Visual Resources Review Board Meeting
Tuesday, August 26, 2025 at **6:00 PM**

AGENDA

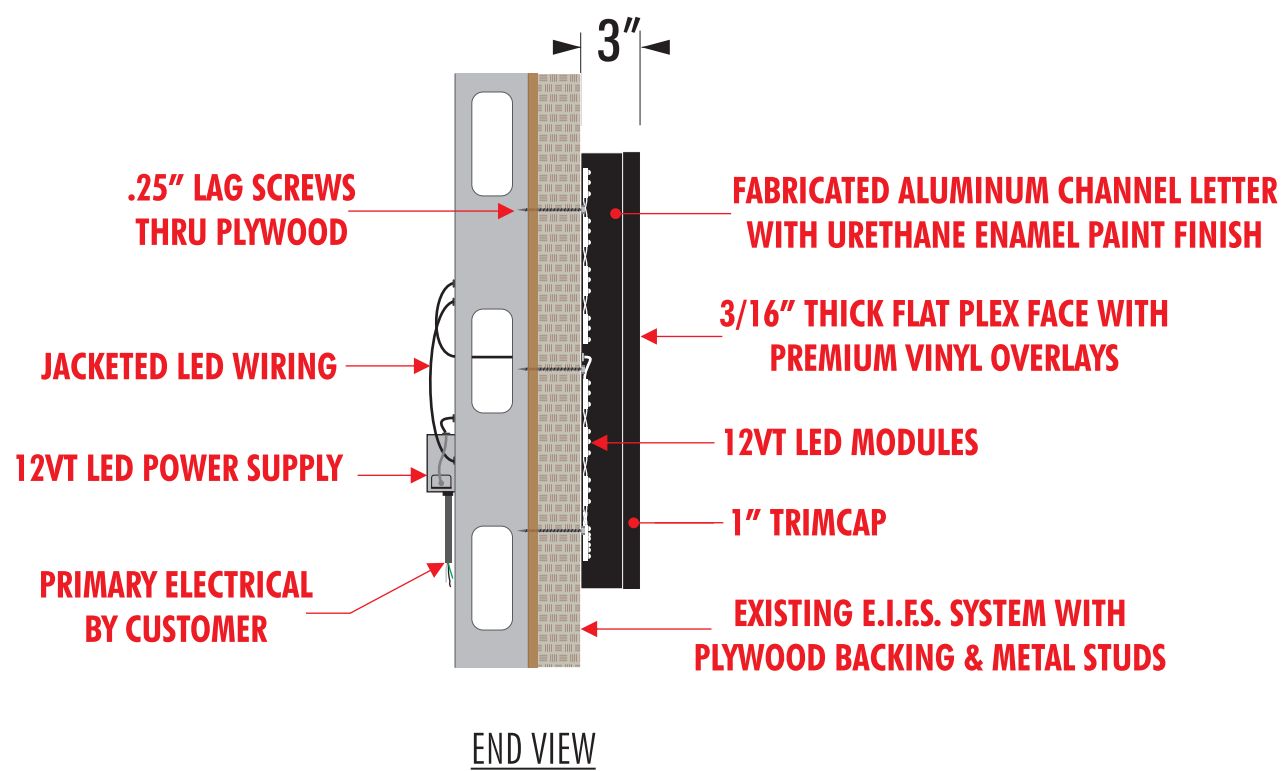
Discussion & Recommendations: As shown on the sign rendering included in the packet, the lettering is black with a white background. The only staff comment is that the lettering should be centered within the tenant panel instead of it being at the top. This would enhance the legibility and effectiveness of the lettering. As shown, there is wasted space on the tenant panel.

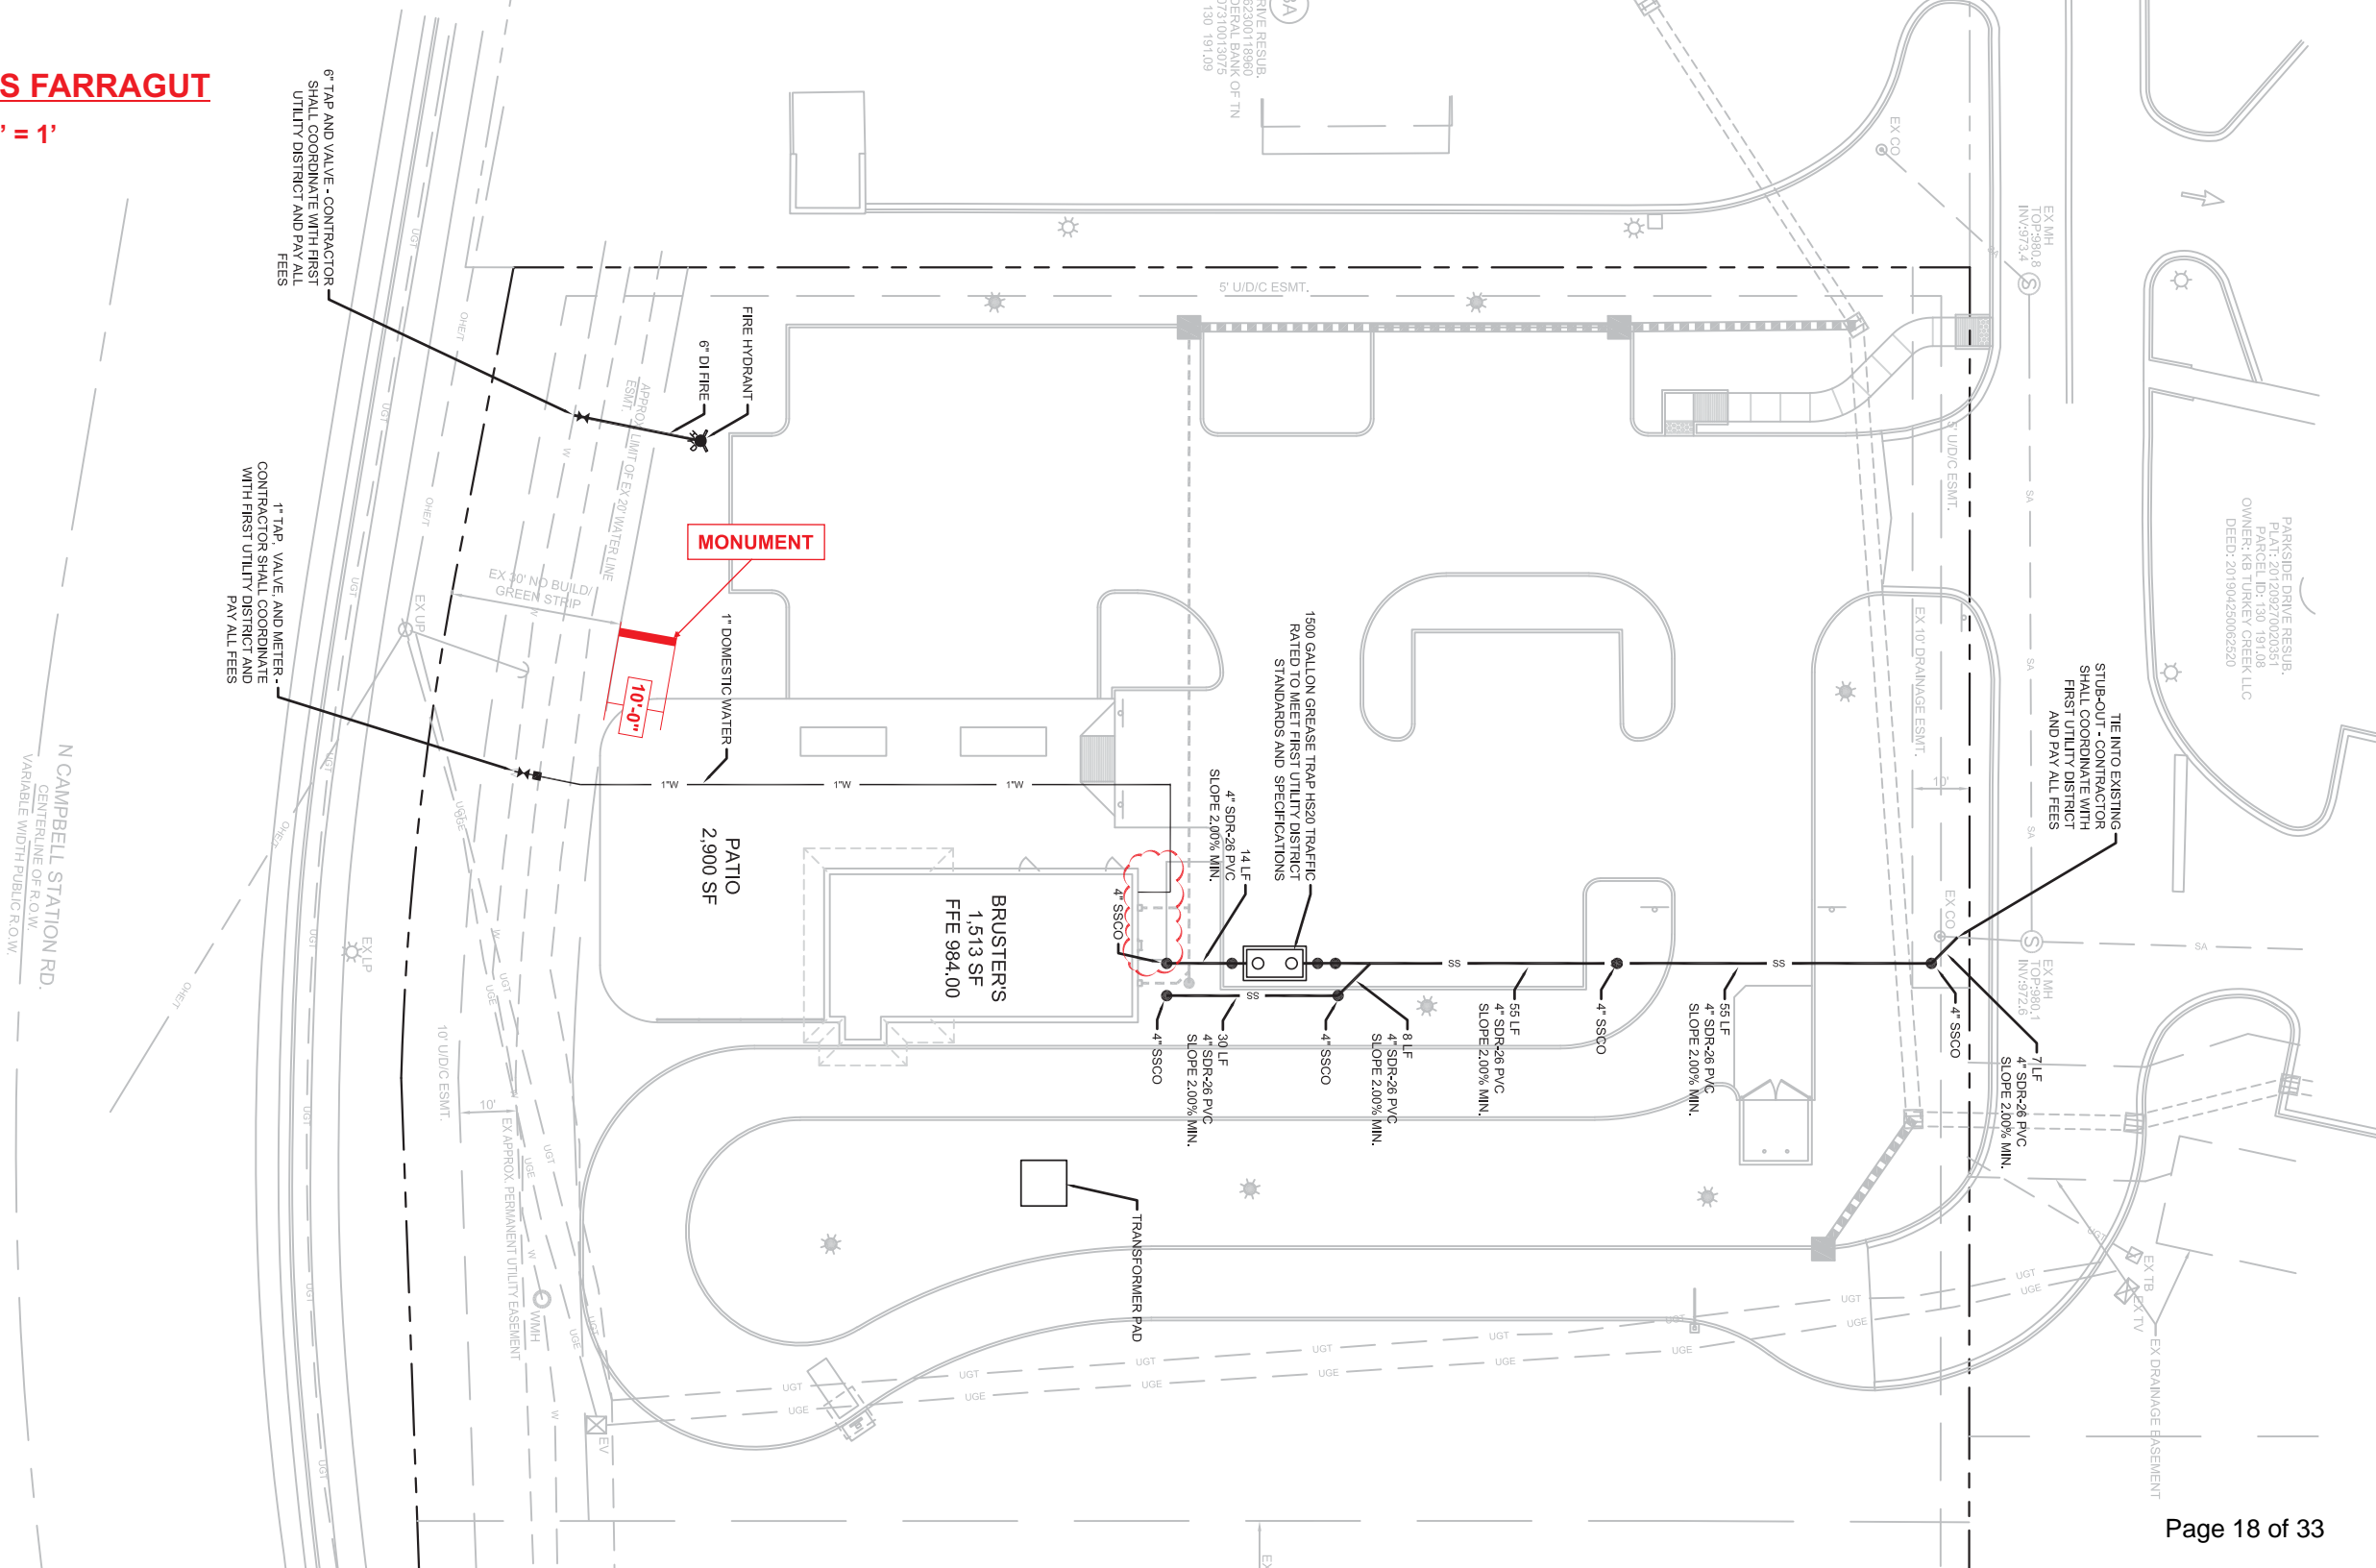
Discussion & Recommendations: Included in the packet is a copy of the sign rendering and site plan. The staff recommends approval of the sign subject to the following conditions:

1. As proposed, the sign is at the edge of a platted utility easement, a foundation survey will be required to ensure that the sign is not within the platted easement and complies with what is shown on the approved plans. The sign will also need to be shown on the as-built survey that will be required prior to the building obtaining a Certificate of Occupancy.
2. The landscaping will need to be coordinated with the Town staff. The plan included in the packet is generic and specific species will need to be provided with Town staff approval. Some possible choices would be Little Henry Dwarf Virginia Sweetspire, Hummingbird Summersweet, and Rose Creek Abelia, These are hardy options that should be commercially available.
3. Please make sure the overall height does not exceed six feet as measured from the highest point of the sign to the average grade around the base of the sign.

To approve the ground mounted sign subject to the following conditions:

1. As proposed, the sign is at the edge of a platted utility easement, a foundation survey will be required to ensure that the sign is not within the platted easement and complies with what is shown on the approved plans. The sign will also need to be shown on the as-built survey that will be required prior to the building obtaining a Certificate of Occupancy.
2. The landscaping will need to be coordinated with the Town staff. The plan included in the packet is generic and specific species will need to be provided with Town staff approval. Some possible choices would be Little Henry Dwarf Virginia Sweetspire, Hummingbird Summersweet, and Rose Creek Abelia, These are hardy options that should be commercially available.
3. Please make sure the overall height does not exceed six feet as measured from the highest point of the sign to the average grade around the base of the sign.

L.10

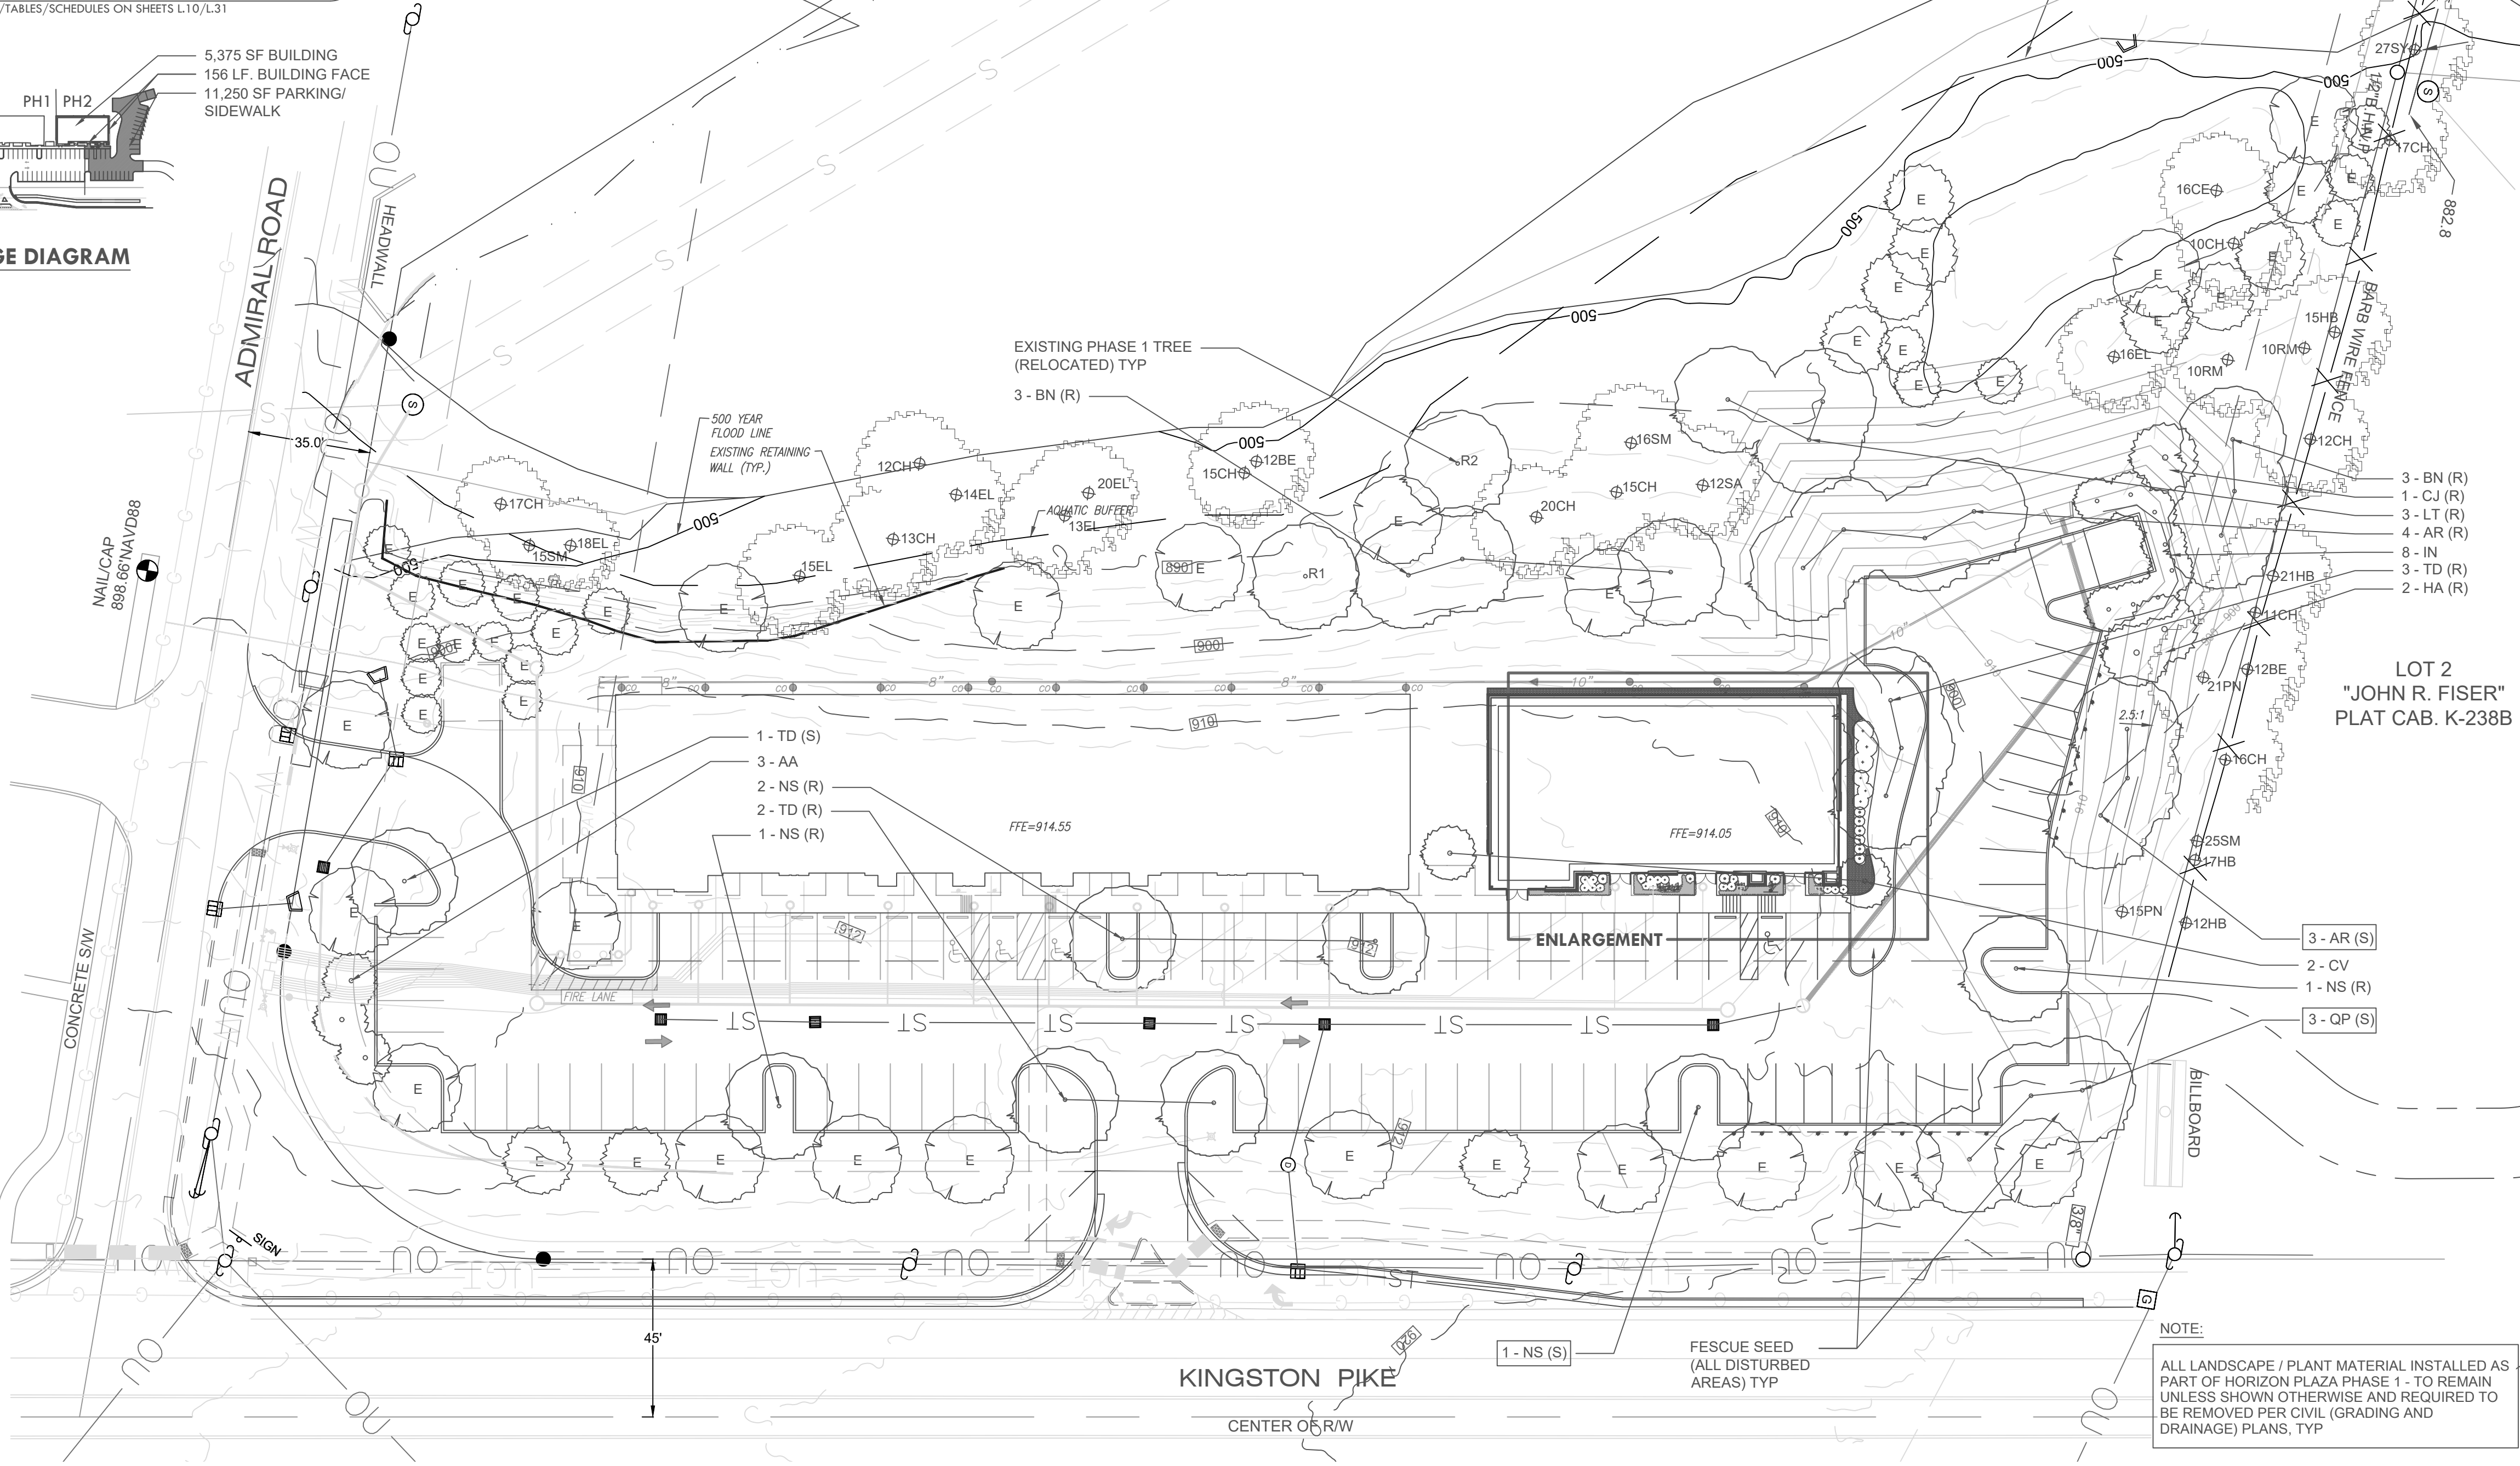
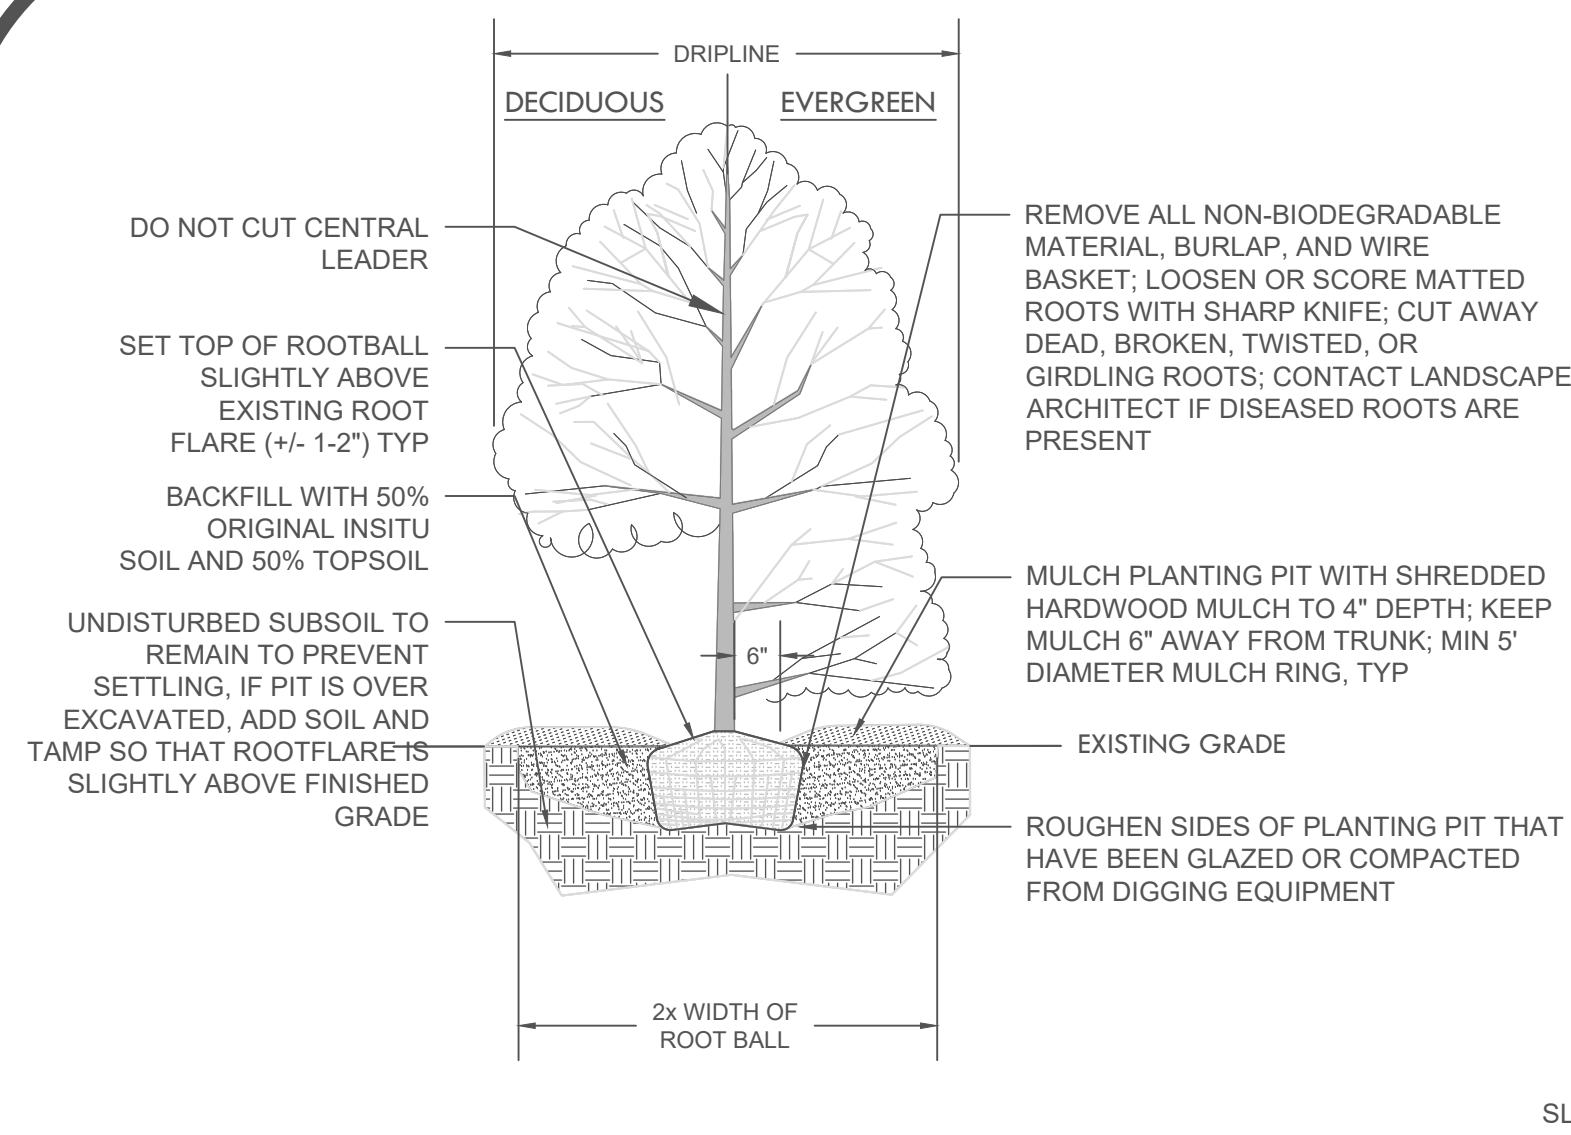
Discussion & Recommendations: This phase of Horizon Plaza is situated on the eastern third of the property and includes a roughly 5,400-square-foot building with associated parking. There is also a vehicular connection to the Stonecrest Shopping Center to the east that is part of this phase. The landscape plan included in the packet addresses the initial staff comments. One item to note for the VRRB's consideration is that the plans show river stone or mulch, along with shrubs, in the landscaped area being counted for the requirements between the building and the parking lot. Where river stone is used it will need to be limited to no more than 25% of this area per the landscape ordinance. With this clarification, the staff recommends approval of the landscape plan.

Proposed Motion: To approve the landscape plan subject to the river stone not exceeding 25% of the landscaped area between the building and parking lot.
